MONTGOMERY COUNTY HISTORIC PRESERVATION COMMISSION
STAFF REPORT

Address:	18 Hesketh Street, Chevy Chase	Meeting Date:	2/7/2024
Resource:	Contributing Resource Chevy Chase Village Historic District	Report Date:	1/31/2024
Applicant:	Robert DiGiovini	Public Notice:	1/24/2024
Review:	Historic Area Work Permit	Tax Credit:	n/a
Case Number:	1055248	Staff:	Dan Bruechert
Proposal:	Hardscape Alterations

PROPOSAL

The applicant proposes to remove the remainder of the concrete driveway in front of the existing garage/shed and install a new gravel and stone walkway and patio.

New
Gravel
Walkway

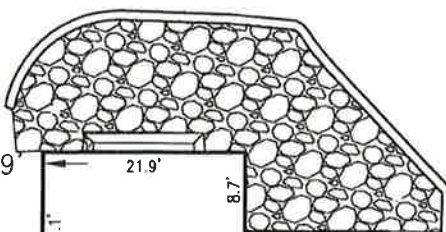
In the rear of the house, there is an exposed aggregate concrete walkway and a vestige of the historic driveway from a time before the existing attached garage was constructed. The existing concrete is cracked and has been selectively patched over the years. The applicant proposes to remove the concrete and install new gravel and stone walkway and patio. The proposed patio appears to be slightly larger than the existing concrete. No trees will be impacted by the proposed work.

Staff finds the proposed changes will not at all be visible from the right-of-way, because the detached garage and change in grade from the street block visibility of the rear yard. Staff finds the existing concrete has significantly deteriorated and its removal will not detract from the character of the site or surrounding district. Finally, Staff finds gravel and stone are preferred materials for hardscaping features in the Chevy Chase Village Historic District because they reinforce the district's characteristic park-like setting. Staff recommends the HPC approve the HAWP under 24A-8(b)(1),(2), and (d); and Standards 2, 9, and 10.

Staff recommends that the Commission **approve** the HAWP application; under the Criteria for Issuance in Chapter 24A-8(b)(1), (2) and (d), and the *Chevy Chase Village Historic District Guidelines*, having found that the proposal will not substantially alter the exterior features of the historic resource and is compatible in character with the district and the purposes of Chapter 24A;
